From: Carrillo, Abiel X.
To: ["Yolanda Padilla Moyer"](#)
Cc: [Biazar, Shahab](#)
Subject: ROFG - Del Webb Phase I @ Mirehaven - H019D017C
Date: Friday, August 26, 2016 2:07:00 PM
Attachments: [Mirehaven Del Webb 1 ROFG Comments.pdf](#)

Based on the information provided in your Certification dated 7-6-2016, and a field visit of the completed improvements, the following comments will need to be addressed before we approve the submittal for Release of Financial Guarantee:

Comment # 1

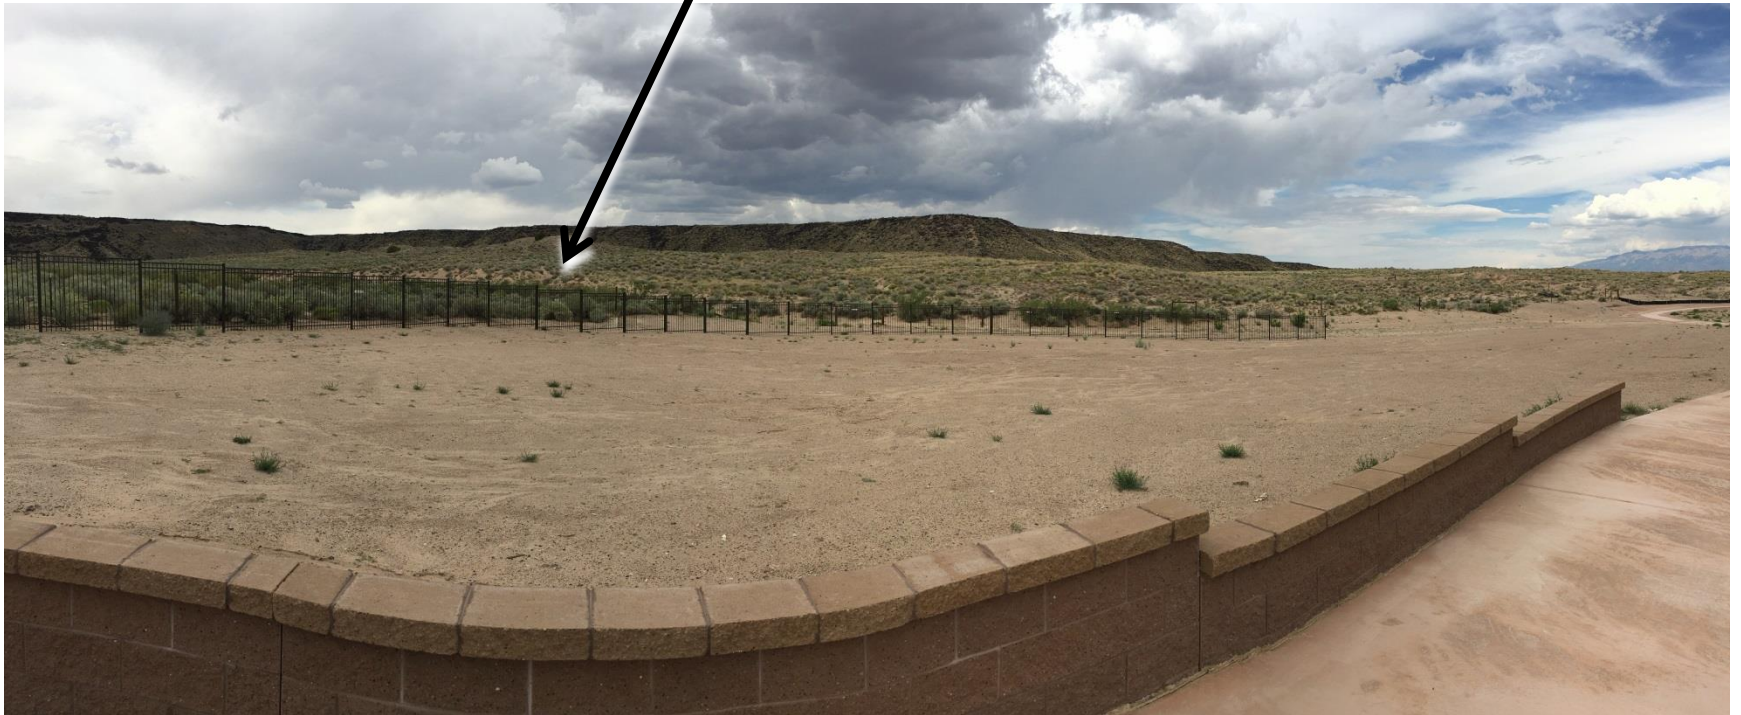
1. There is a wrought iron fence that is encroaching into the Mirehaven Arroyo Floodplain. It's not clear that it offers additional protection then the existing wire strand fence, but it can trap debris and it affects the limits of the floodplain. This fence may not be able to remain if it is impacting the floodplain. See attached.

Fence in the arroyo floodway/plain

Comment # 2

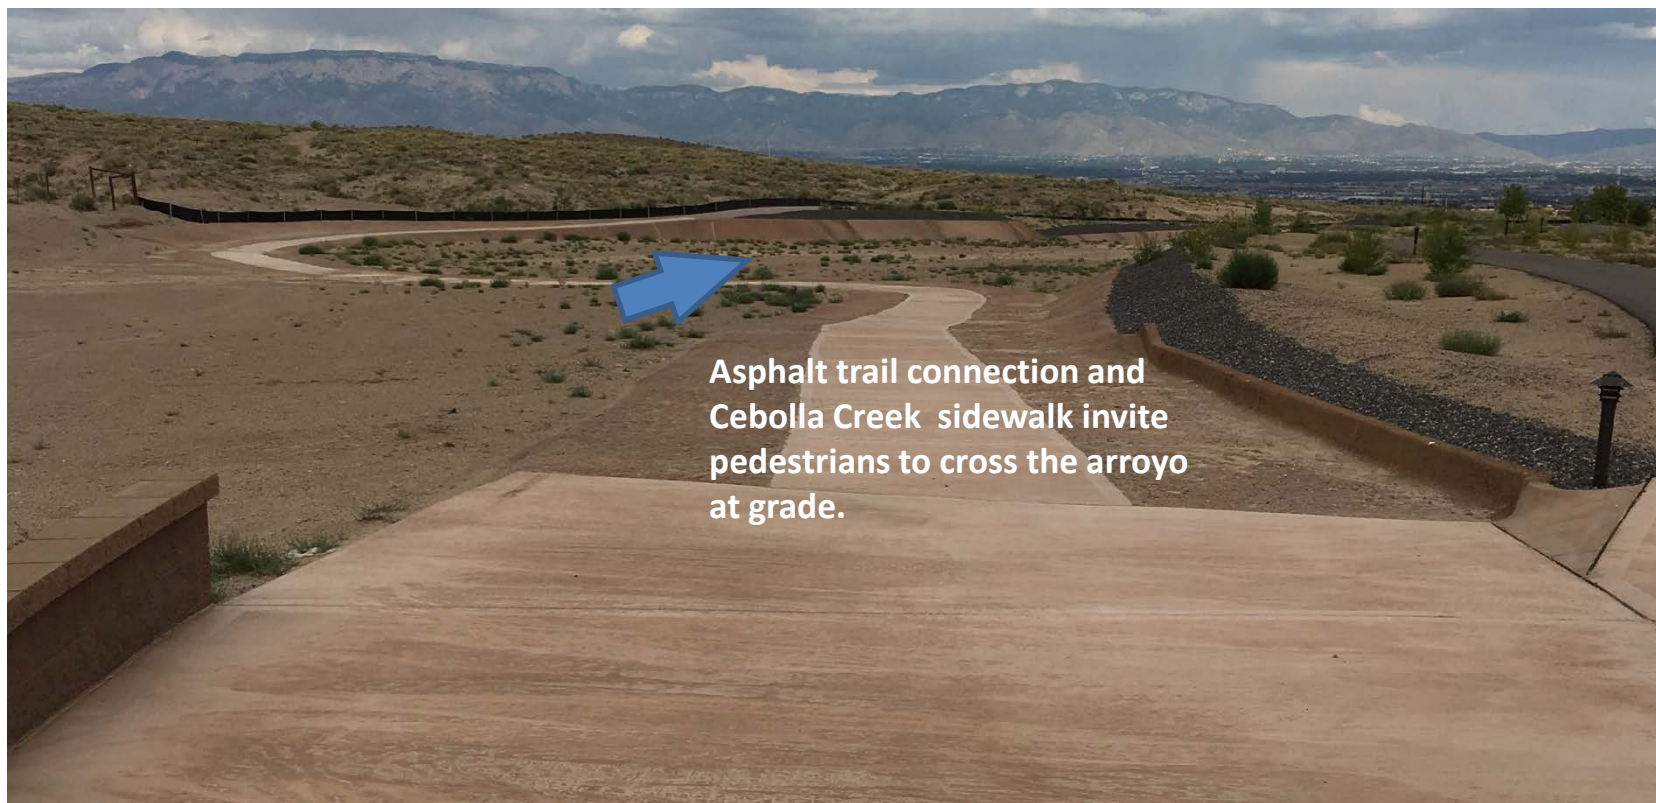
2. Sheet 2B shows a change to the approved plans which re-directs the diversion channel onto the pedestrian trail/sidewalk connection behind lots 172 through 177. It is not acceptable to discharge the channel directly onto the pedestrian trail. It is clear that the intent for the colored concrete segment was to provide a pedestrian connection. As a corrective measure, a swale could be constructed behind the wall of the concrete pedestrian path and connect to the Arroyo (may not need to be shotcrete/concrete if the energy can be dissipated).
